62-F-271M
LOT 67, ROAD
BETWEEN L.R.E.
+ L.R.W. CONS.
CULVERT C-12-16
BEITH CREEK
BOSANQUET

Mr. A. G. Stermac,
Principal Foundation Engr.,
Foundation Section,
Materials & Research Division.
October 25, 1962.

Soils Report by E. M. Peto Assoc., Ltd.
County of Lambton,
Proposed Pipe Culvert,
Township of Bosanquet,
Lot 67, Rd. between L.R.E. & L.F.W. Cons.,
Bridge Office Ref. #BA 1517.

ROAD CULVERT C-12-16	
BEITH CREEK	
RD #12 ST. 112-00 PL. NO. R24-4	
Drawn: O.V.D.	Traced:
COUNTY OF LAMBERTON	Appr. <i>[Signature]</i>
ENGINEERING DEPT.	Date: Sep 25/62
	Scale: as noted
County Eng. Ovan Dews	PL. NO. B-41

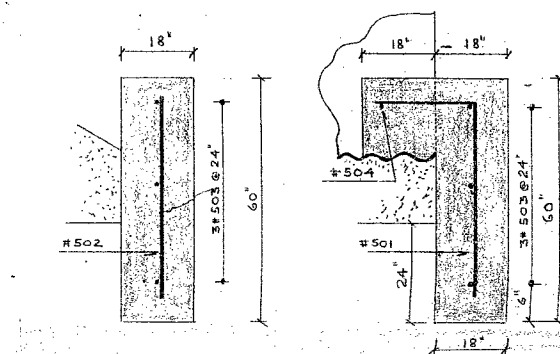
In connection with the granular cushion, we would recommend that it be provided irrespective of whether the culvert is moved or remains at the proposed location.

It also appears to us that the embankment slopes could be steepened from 2.5:1 to 2:1 because the stability would still be adequate and some saving could be accomplished.
